UNITED STATES PATENT AND TRADEMARK OFFICE

APPLICATION NO.	FILING DATE	FIRST NAMED INVENTOR	ATTORNEY DOCKET NO.	CONFIRMATION NO.
10/659,478	09/10/2003	Carl E. Yee	BSI-260US3	3432
23122	7590	05/11/2007		
RATNERPRESTIA P O BOX 980 VALLEY FORGE, PA 19482-0980			EXAMINER PREBILIC, PAUL B	
			ART UNIT 3738	PAPER NUMBER
			MAIL DATE 05/11/2007	DELIVERY MODE PAPER

Office Action Summary

1/9

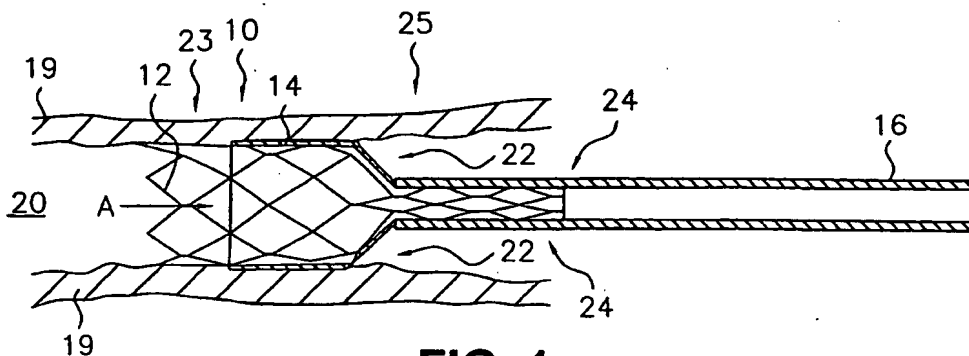
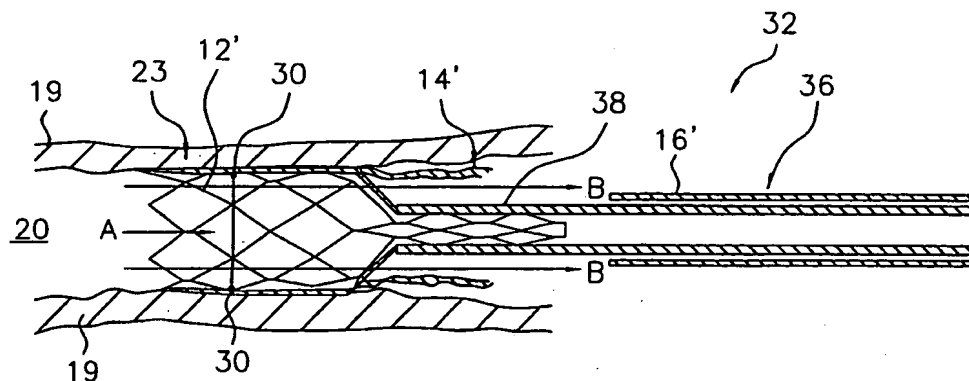
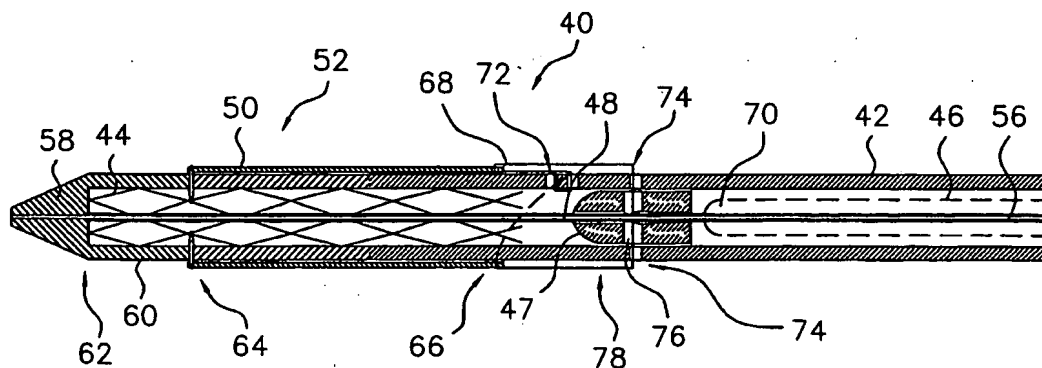
The proposed drawing changes filed July 24, 2006 have been approved with respect to replacement page 1/9 that corrected the lead line of reference number 68. However, replacement page 6/9 has not been approved because reference number 50 appears to now point to the blood vessel and not to the graft as it should.

Approved
 for
 Entry
 PBP
 5/9/07

6/9

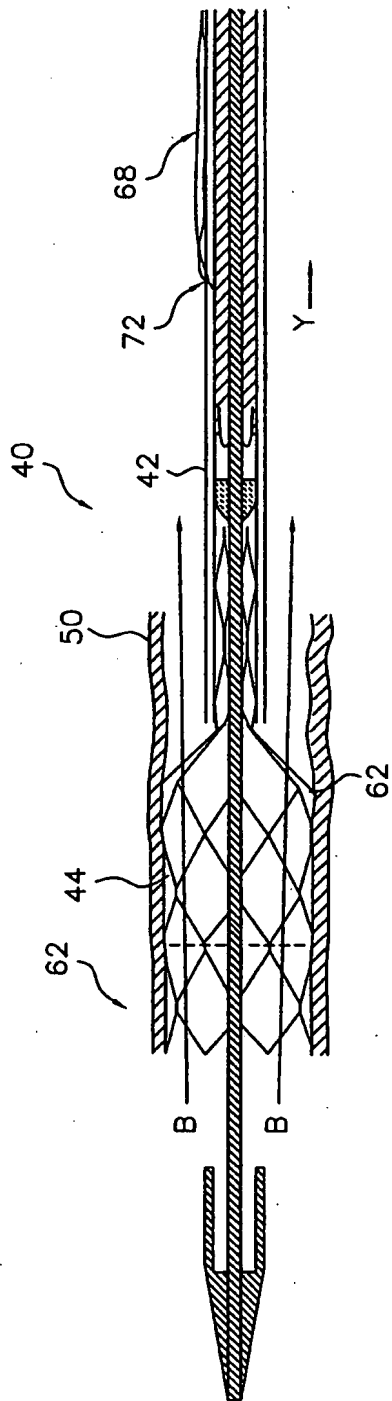
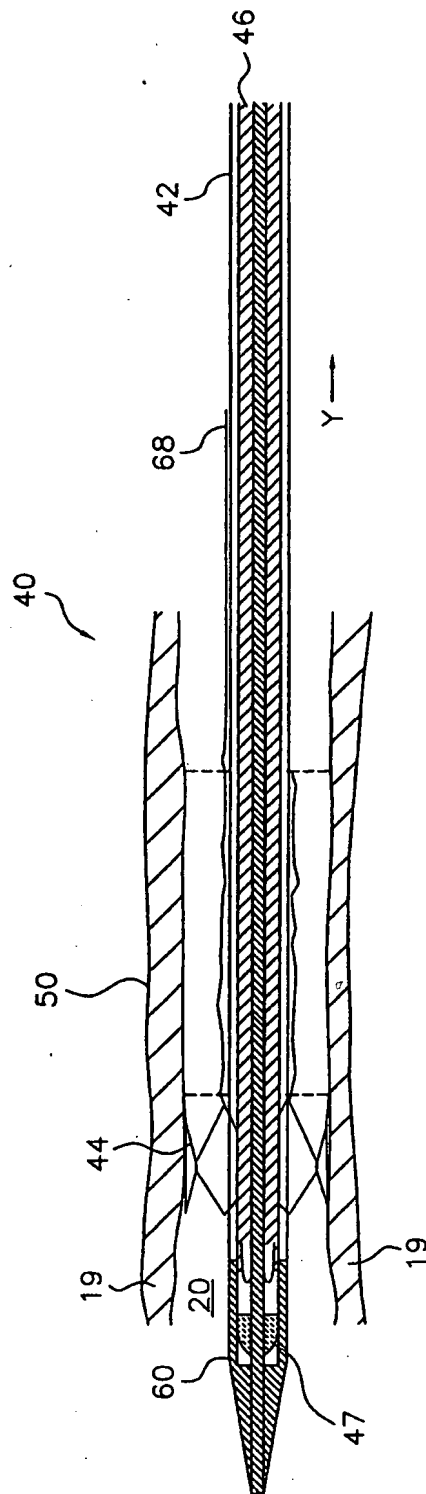
Not
 Approved
 for
 Entry
 PBP
 5/9/07
